VS
FLORIDA CRUSHED STONE COMPANY
APPLICATION FOR CERTIFICATION
POWER PLANT SITE

Florida Crushed Stone Company
Proposal to Reduce SO₂ Emissions

Amendment No. 3
December 30, 1982

Re: Florida Crushed Stone Company Power Plant Site
Certification Application No. PA 82-17

Figure 3.10-1

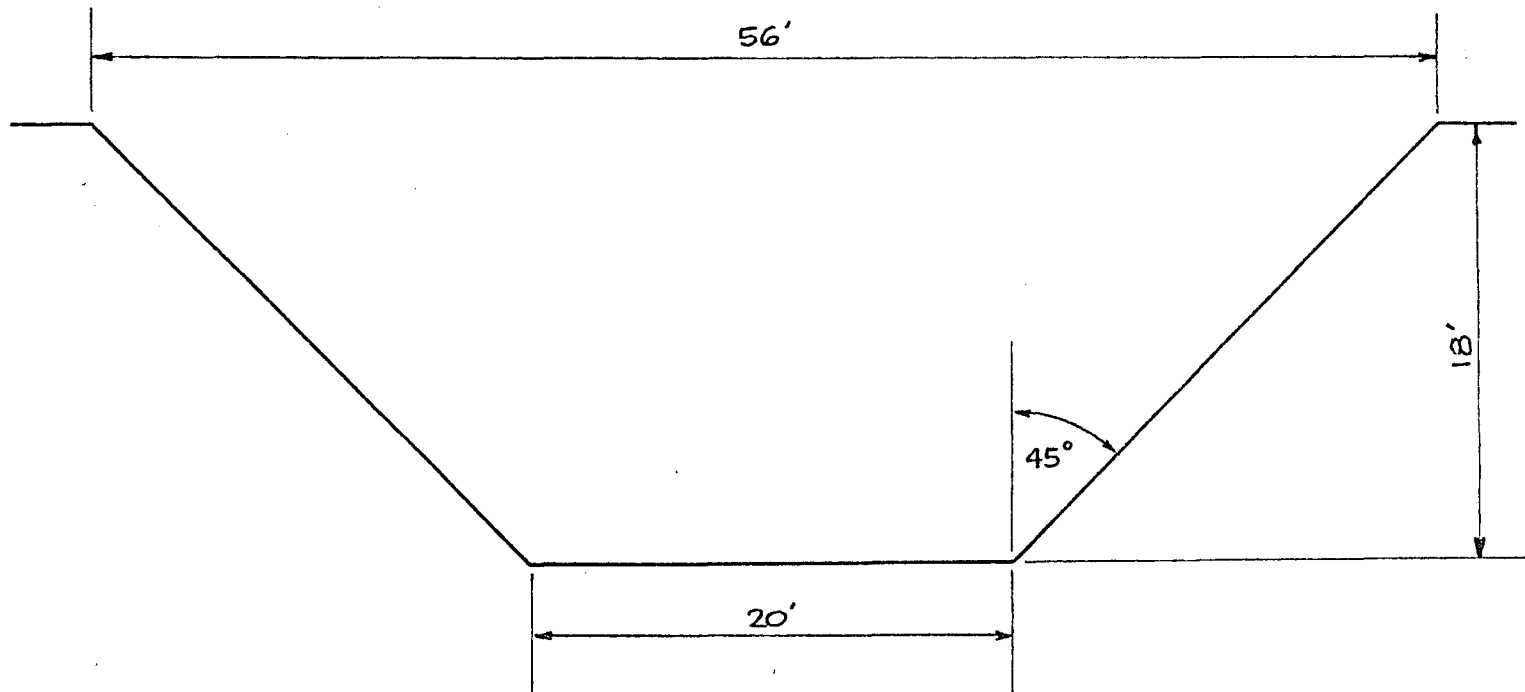
Question 10 - The nature of the retention basin, its configuration and capacity, as well as the dimensions, slopes and ultimate destination of the drainage ditches and design criteria for the ditches are shown in Figures 3.1-10 and 3.10-1.

FIGURE 3.1-1

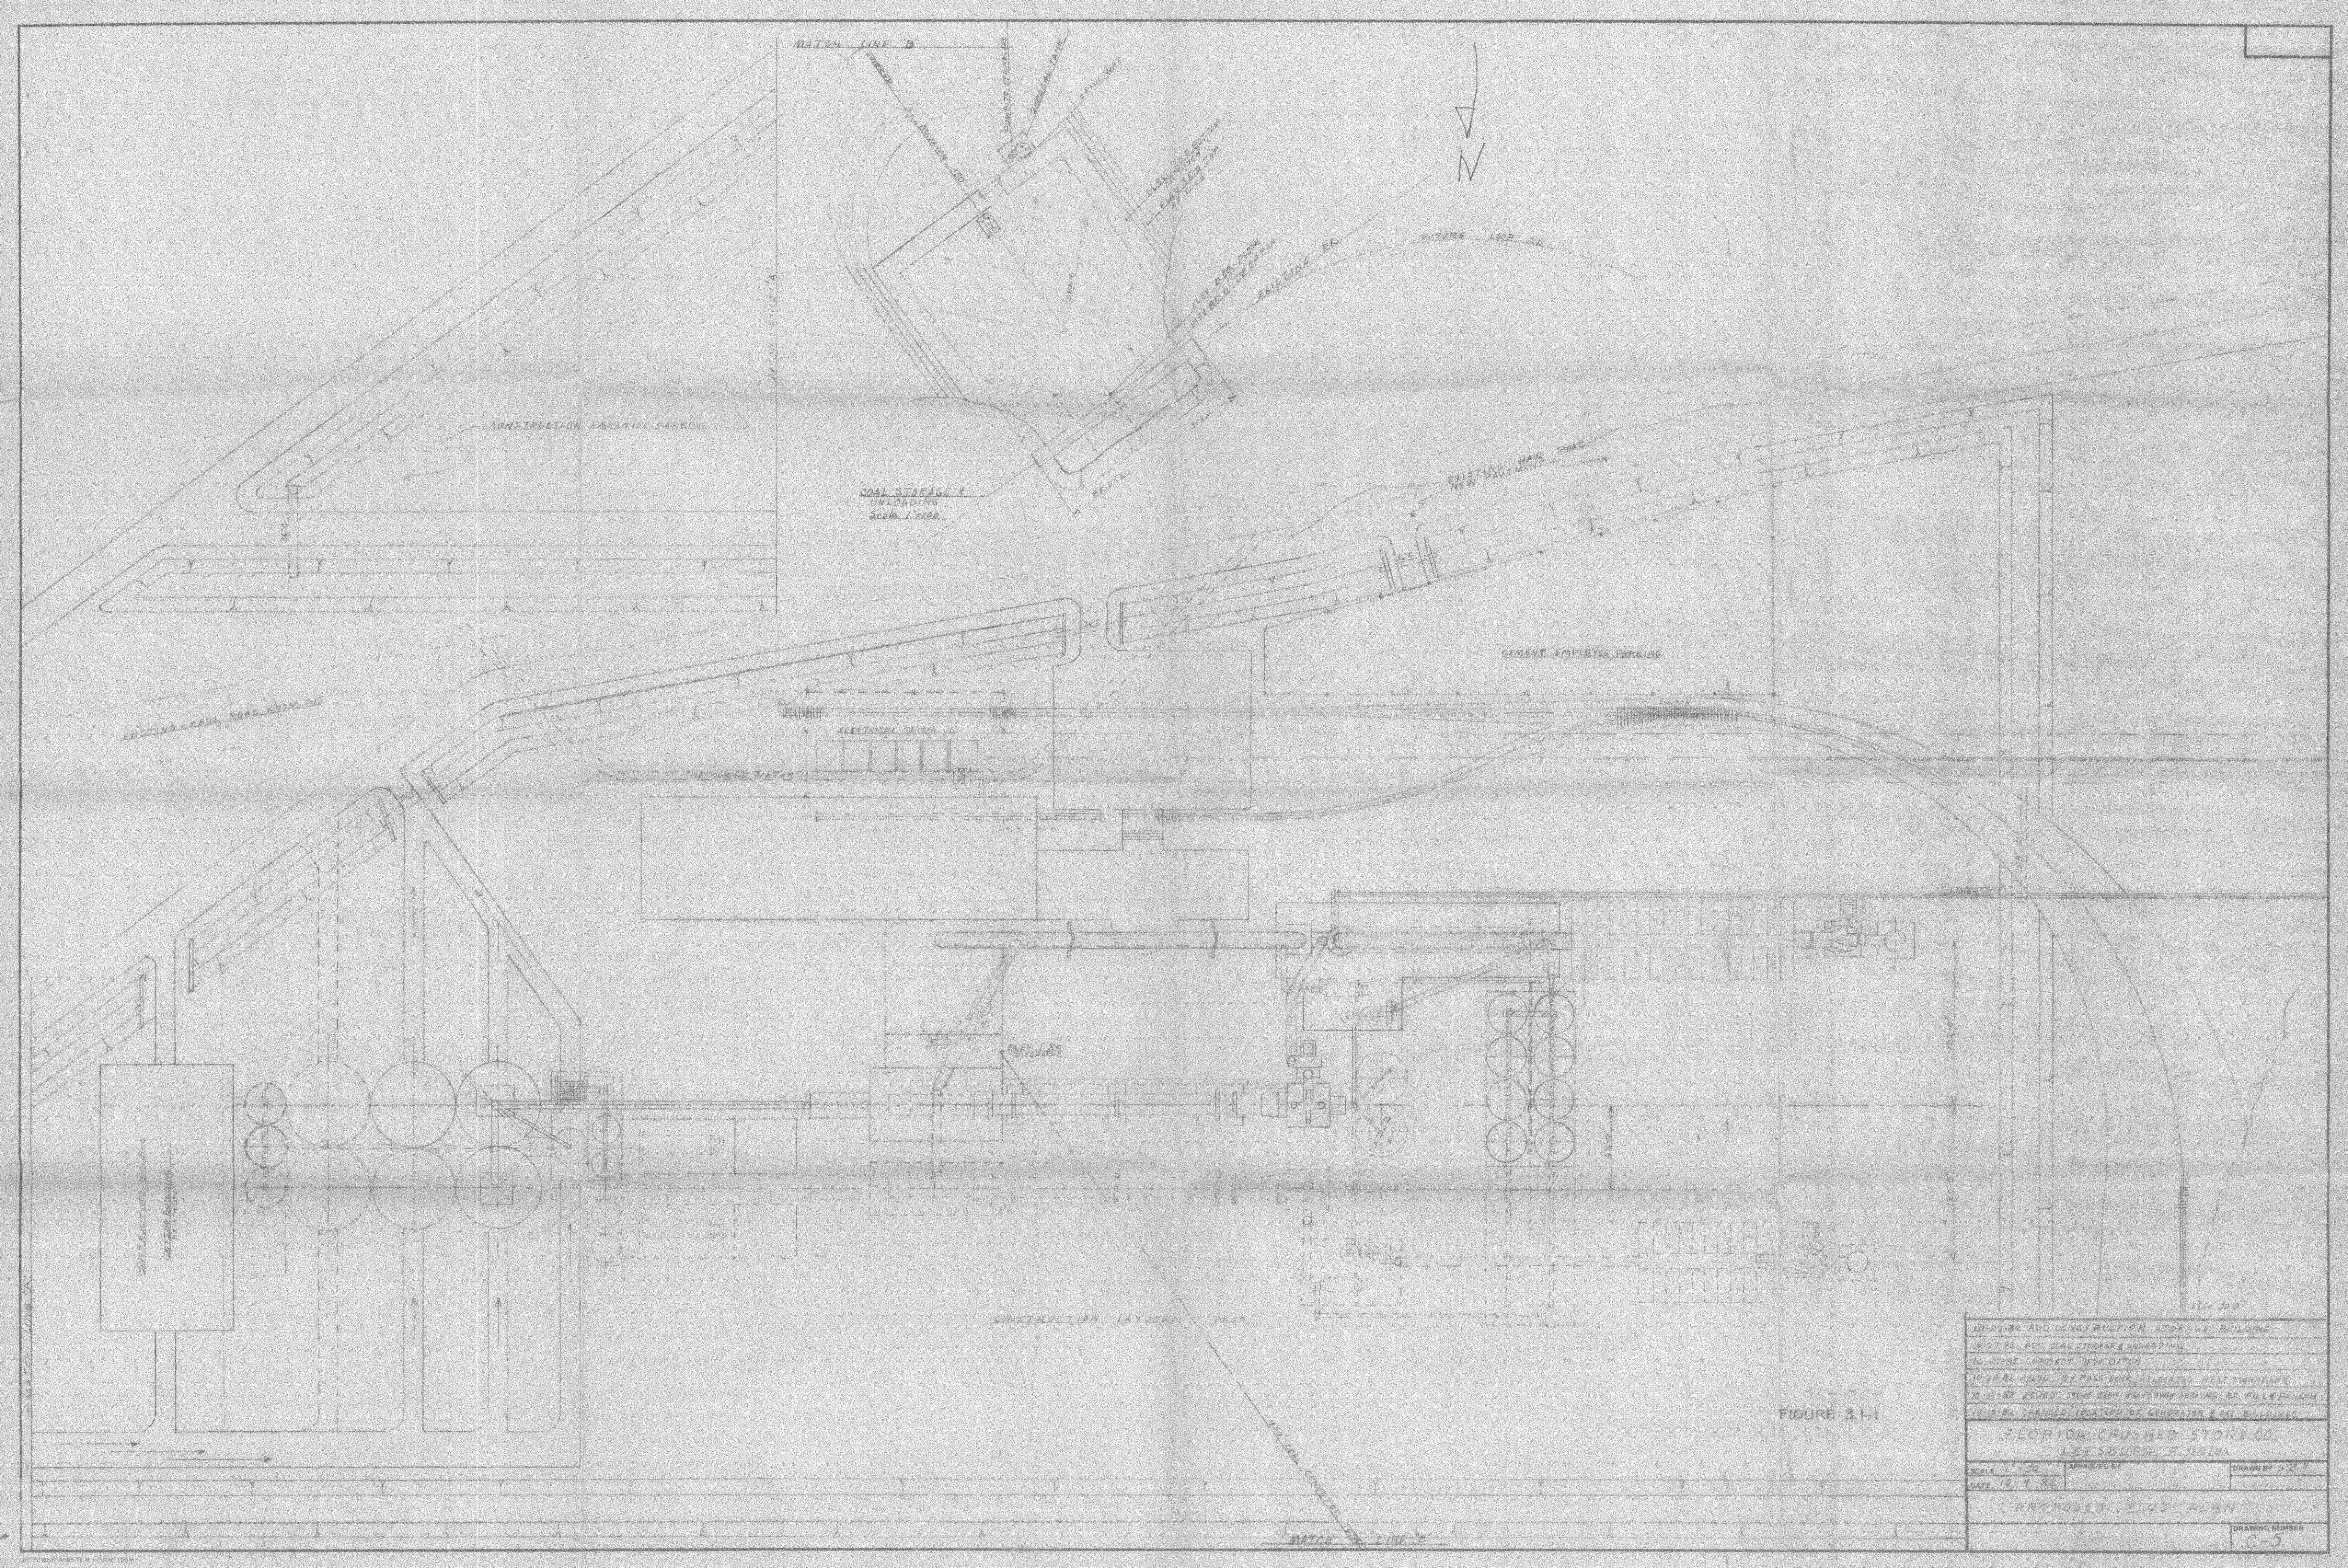
Question 2 - A detailed plot plan showing the coal pile, coal unloading area and coal conveyor is contained in Amendment No. 1 to the application as Figure 3.1-1.

3.9.2-1

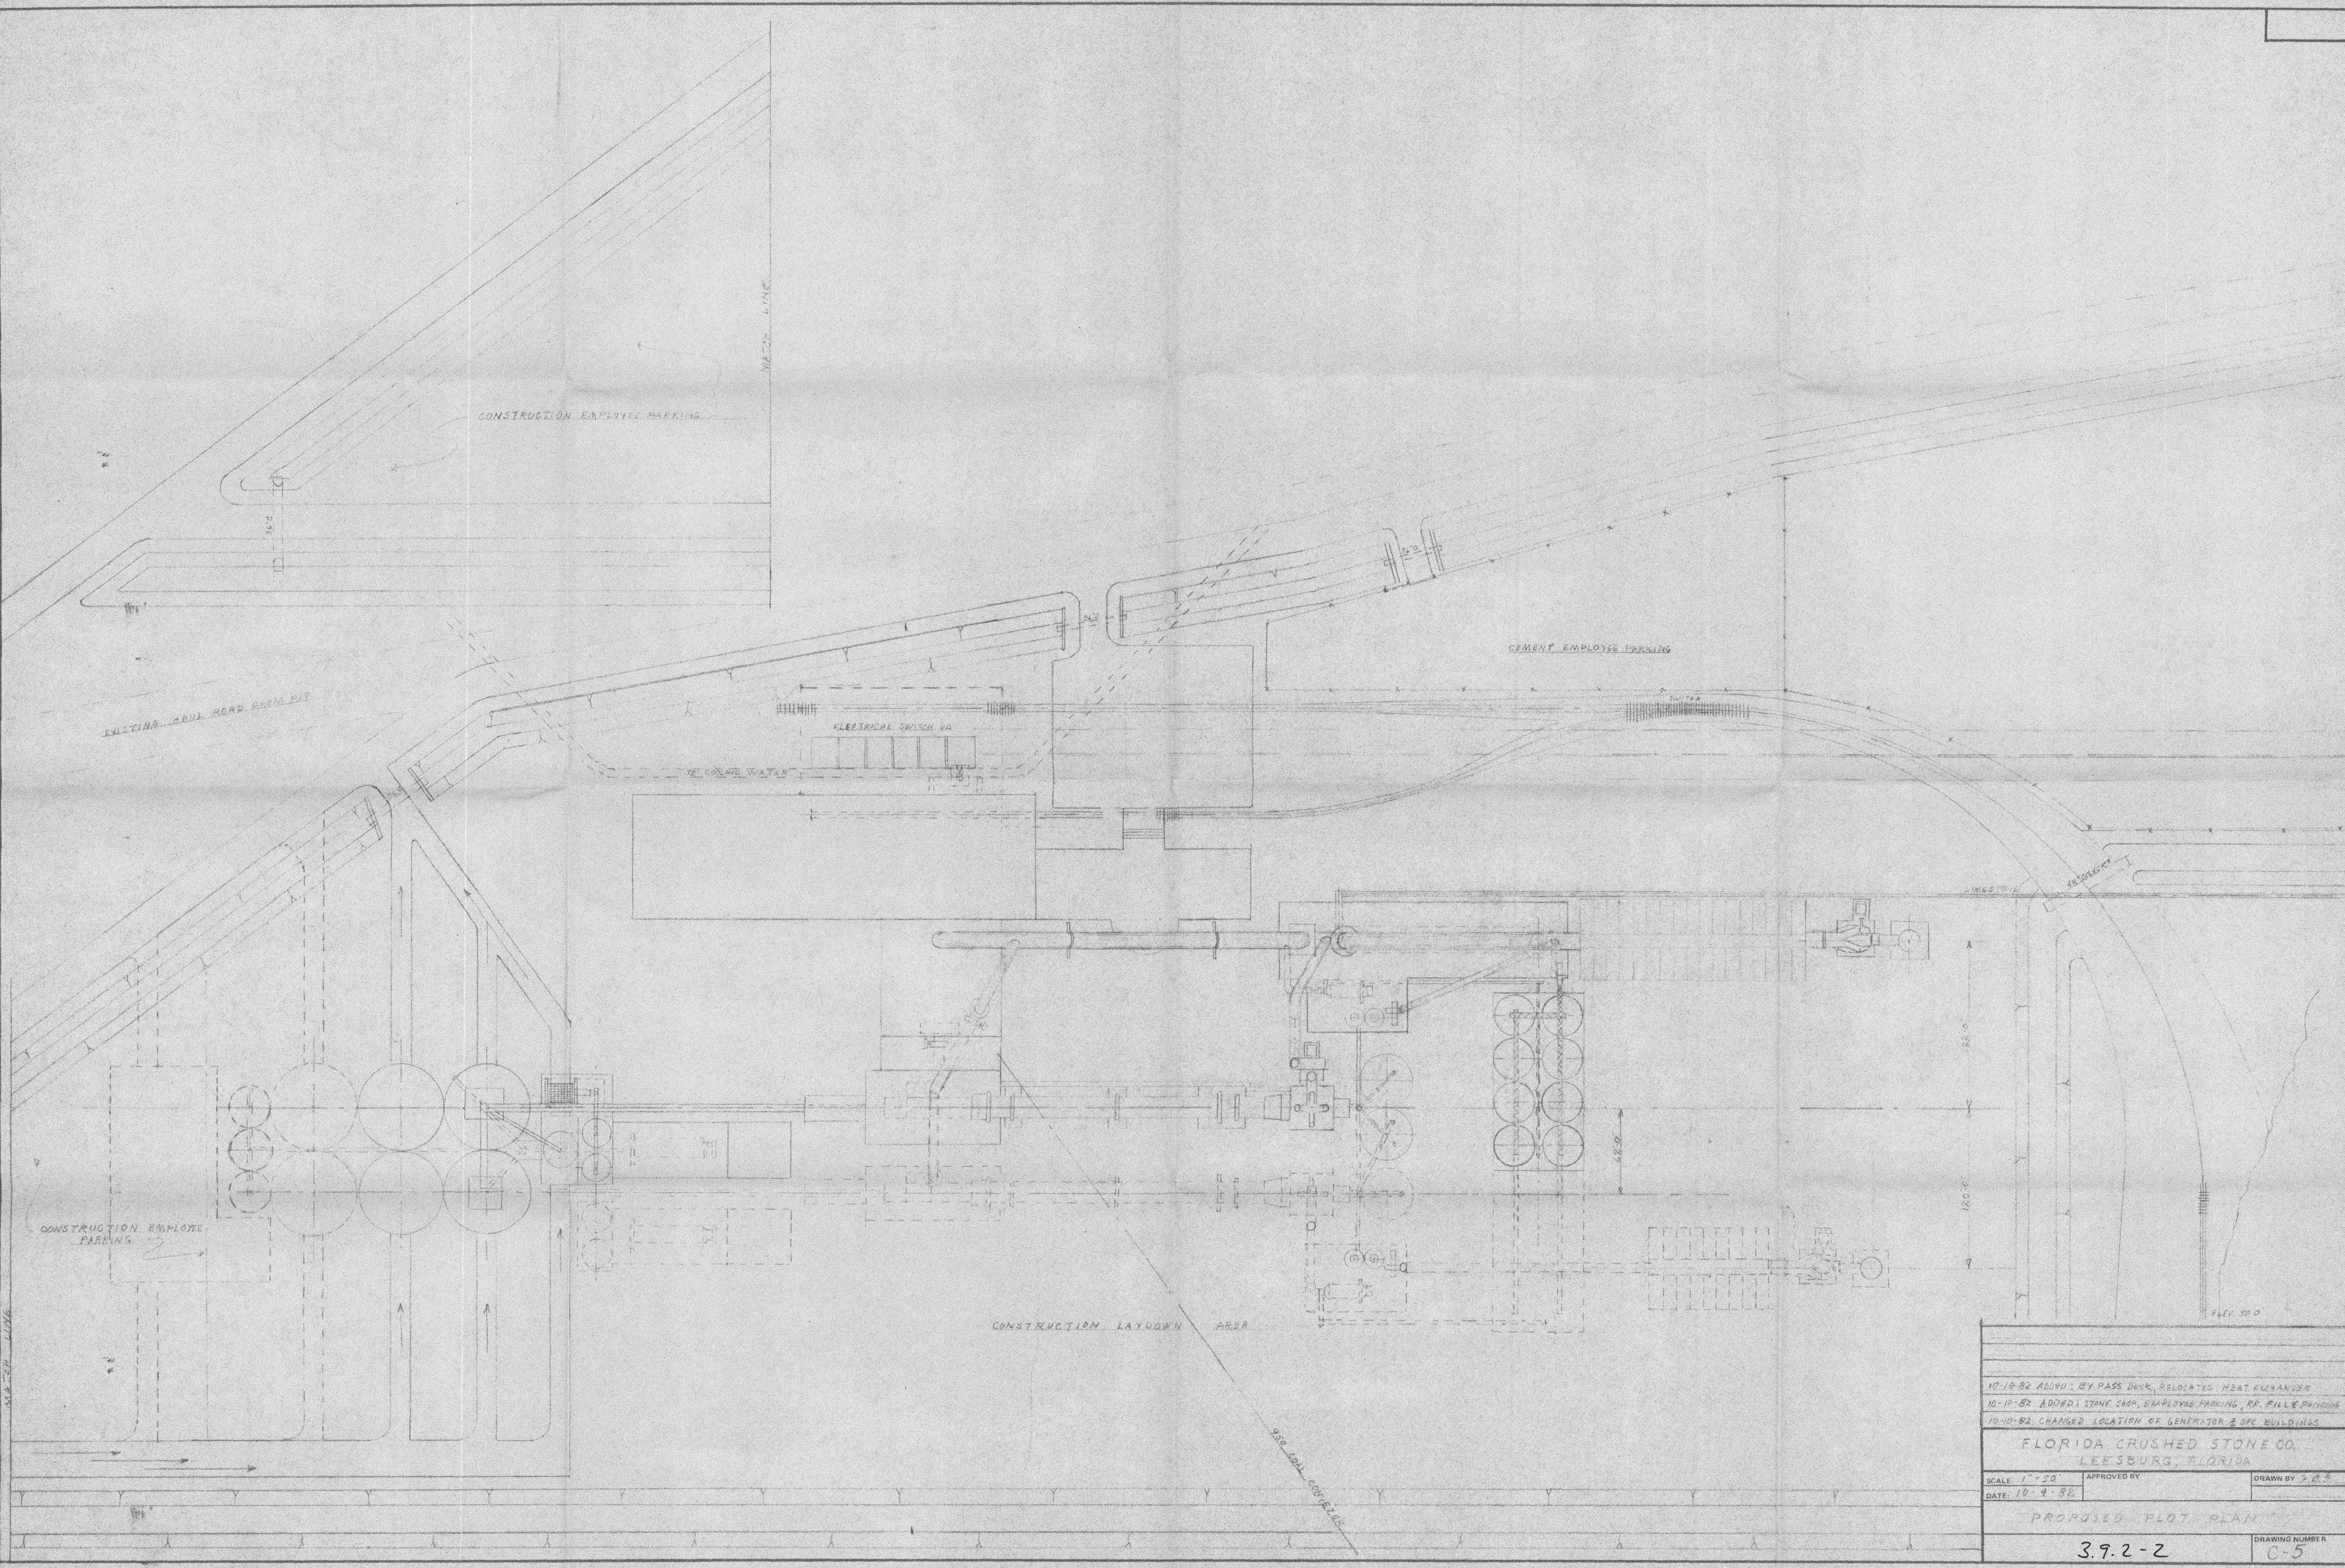
Question 9 - Figure 3.9.2-2 has been revised to identify the structures. However, in using this figure the configuration of the ditched area should be disregarded. The ditched area is shown in Figure 3.1-1.
